#05-06-05-001: Buzz Type Noise Heard Inside Vehicle (Remove Resonator Shield and Install New Underbody Tunnel Insulator) - (Jan 19, 2005)

Models: 2005 Cadillac STS
with Heat Shield on Exhaust Resonator and
3.6L V6 Engine (VIN 7 -- RPO LY7) Built Prior to July, 2004 or
4.6L V8 Engine (VIN A -- RPO LH2) Built Prior to August, 2004

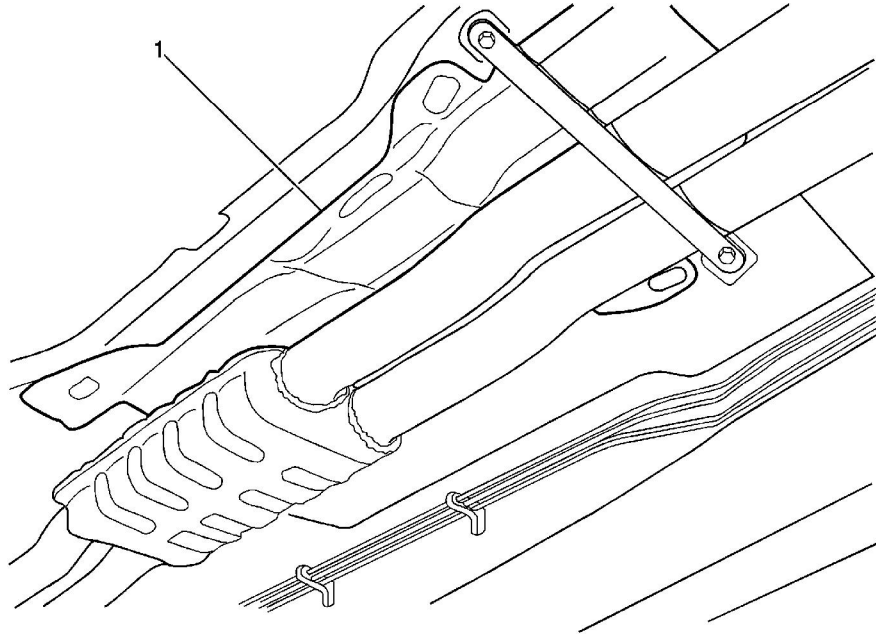
Some customers may comment on a buzz type noise heard inside the vehicle. This noise occurs during driving conditions when the engine is between 2000 and 2200 RPM and is most noticeable when the vehicle is under a slight load for an extended period of time.

This noise may be from the exhaust resonator shield rattling.

Remove the exhaust resonator shield and install the new underbody tunnel insulator using the procedure listed below.

7. Install the new underbody tunnel insulator (1) and secure using retainers.
8. Raise the exhaust system into position and press the hangers over the hanger rods.
9. Install the floor panel tunnel brace and bolts.
